Applicant: Appl. No.: John R. Stice

Analog to Digital Converter Utilizing Resolution Enhancement

BRIEF ON APPEAL

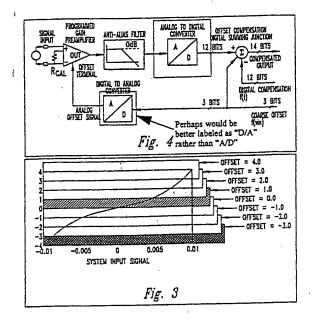
Whether the drawings show the features specified in the claims, viz. the converter of line 2 of claim 5, the hysteresis in line 6 of claim 7, and the AD converter performing the method of claim 8.

It is not clear how overlapping the offset bands can provide the hysteresis as recited in line 6 of claim 7 since Fig. 3 of the present invention does not show any analog to digital converter and the hysteresis in combination with the offset bands.

The analog to digital converter is the top block labeled "A/D" in Fig. 4 and the hysteresis referred to is a mathematical operation shown schematically by Fig. 3. There is not a dedicated hardware item which performs the hysteresis function. Hysteresis is applied as part of the coarse offset which originates as part of the device's digital controls. Note that in Fig. 4 there are three bits controlling coarse offset. These three bits correspond to the eight levels of offset illustrated in figure 3, since $2^3 = 8$ as originally discussed in the patent application's opening remarks.

Figure 4 shows two blocks labeled "A/D." Customarily, "A/D" refers to an analog to digital conversion function. One of the blocks shown in figure 4 is in reality a digital to analog converter, customarily referred to as "D/A." This typographical error is possibly confusing to those seeing the figure for the first time.

By way of further explanation, the hysteresis function is provided for those situations in which the signal being processed is just on the edge of transitioning from one offset range into an adjacent offset range: Suppose hysteresis was not provided. The offset ranges would not overlap as shown in figure 3, but would rather abut one another. In this case, should a signal make a transition from one offset range into the adjacent offset range and then for whatever reason quickly transition back into its original offset range (which could easily be the case for a signal "hovering" close to a range boundary), an undesirable effect of continuously switching ranges could occur. Providing hysteresis in which offset ranges overlap as shown in figure 3 eliminates this effect. Once the signal transitions into an adjacent offset range, it finds itself in the middle of this new range rather than on the range's edge as would be the case if hysteresis were not provided.

Again, the basic idea behind hysteresis is that once an input signal transitions into an adjacent offset range, it finds itself in the middle of this new range rather than on the range's edge as would be the case if the ranges abutted rather than overlapped. Hysteresis prevents a signal from leaving an offset range until it crosses that range's boundary. Once it crosses a range boundary,

it then finds itself in the middle of the adjacent range so that it cannot immediately return to the range from which it started. This presents continuous, undesirable range changes.

First, the word "span" in this context refers to the range of voltages which can be accommodated by the analog to digital converter block labeled "A/D" shown in Fig. 4. This "A/D" block must be distinguished from the digital to analog converter block unfortunately also labeled "A/D". The mark-ups on the above figures, hereby made of record, should clarify which is which.
